**Public Comment  
COACHELLA VALLEY BI TMDL  
Deadline: 6/22/11 by 12:00 noon**

**Re: Comment Letter – Coachella Valley Stormwater Channel Bacteria Indicators TMDL**

Figure 1: Caltrans Facilities within the City of Coachella

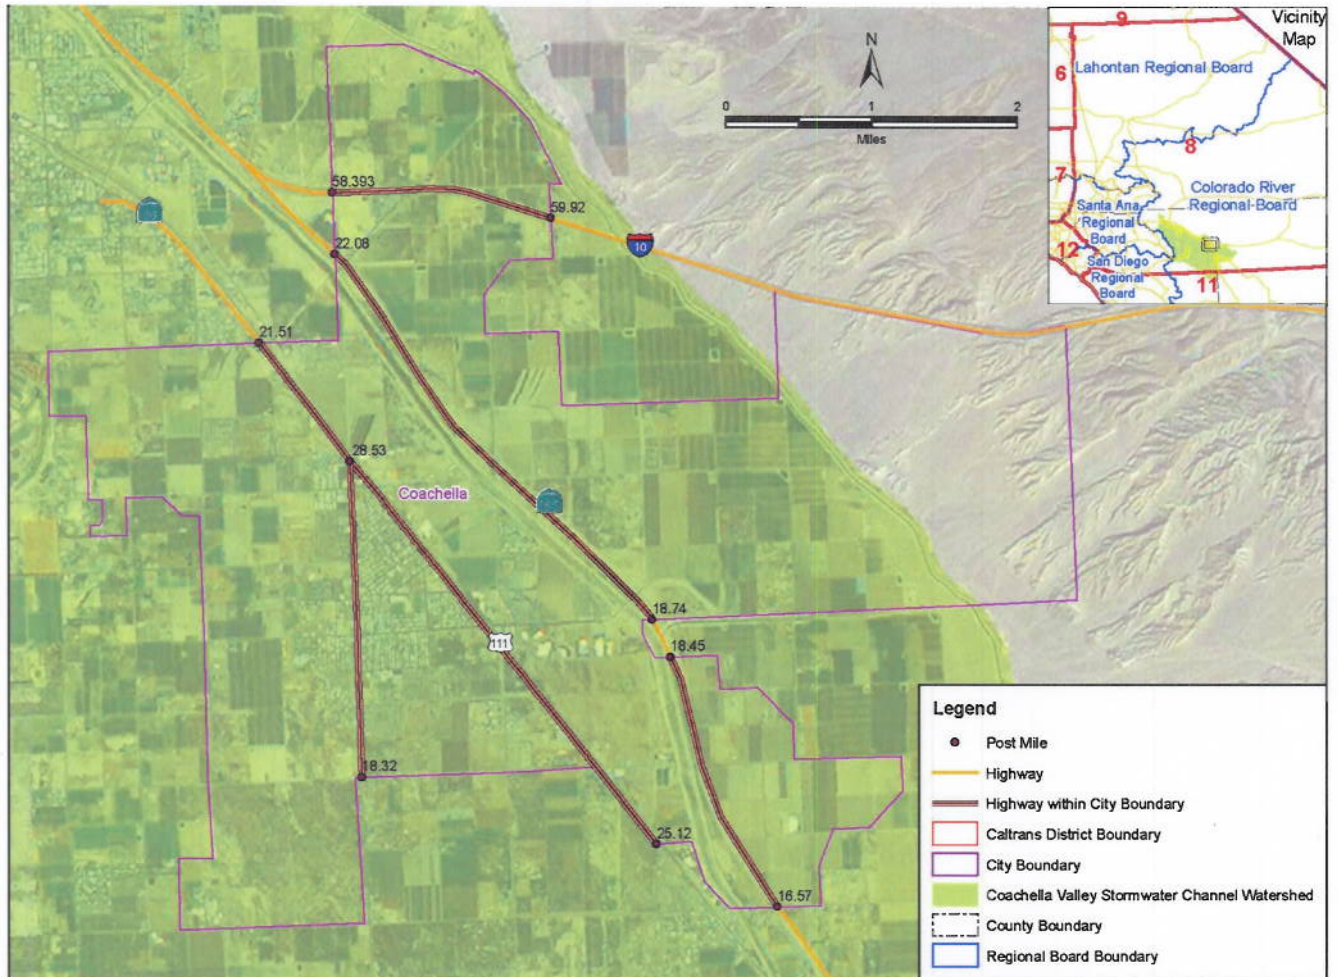
**It is our understanding that the only Caltrans MS4 facilities included in the TMDL are those located within the boundaries of the City of Coachella. This area is shown in Figure 1. In addition, we understand that Caltrans facilities outside of the City are not covered by this TMDL. Please verify our understanding of the extent of the watershed included in the TMDL.**
